# Office Action Summary

10/063,893

LIU, CHUNG-YUAN

## **DETAILED ACTION**

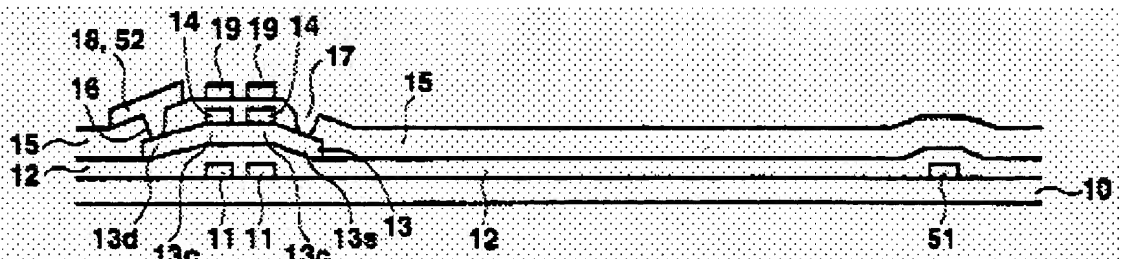
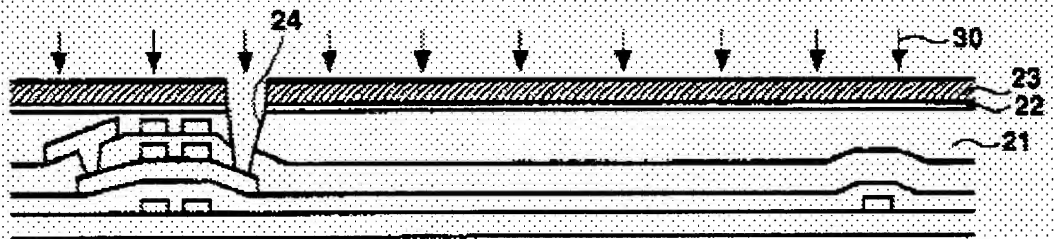
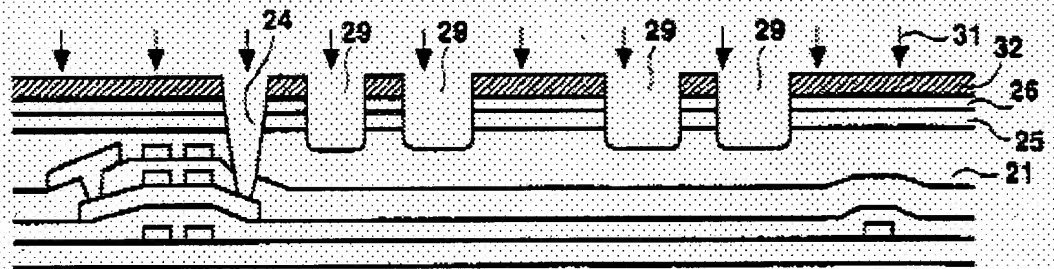
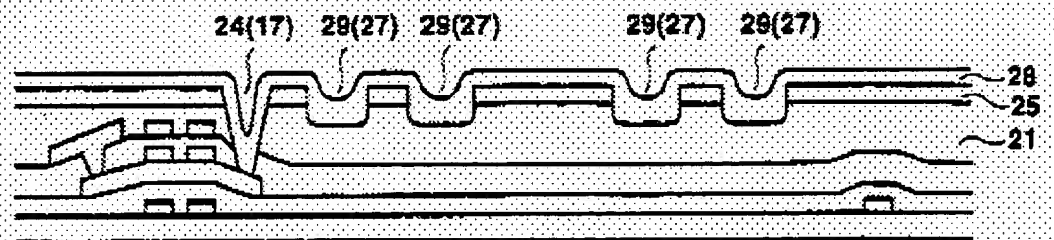
1. Applicant's arguments filed September 30, 2004 have been fully considered but they are not persuasive.
2. Applicants contend that amending claims 1, 5, 7 and 9 with the present amendment "simultaneously" forming at least one transistor "and a plurality of bumpy stacked structures" would render the Noritake et al., U.S. Patent 6,410,358 B1 herein known as Noritake moot.
3. In response to Applicants contention that the newly added terms "simultaneously" and "bumpy stacked structures", will obviate the Noritake prior art reference please see the following drawings where the bumpy stacked structures are formed simultaneously.

4. Noritake discloses at least one transistor and a plurality of stacked structures having different widths. Please note that the gate signal line 51 and first gate electrode 11 will be formed simultaneously having a bumpy effect on the substrate (not numbered).
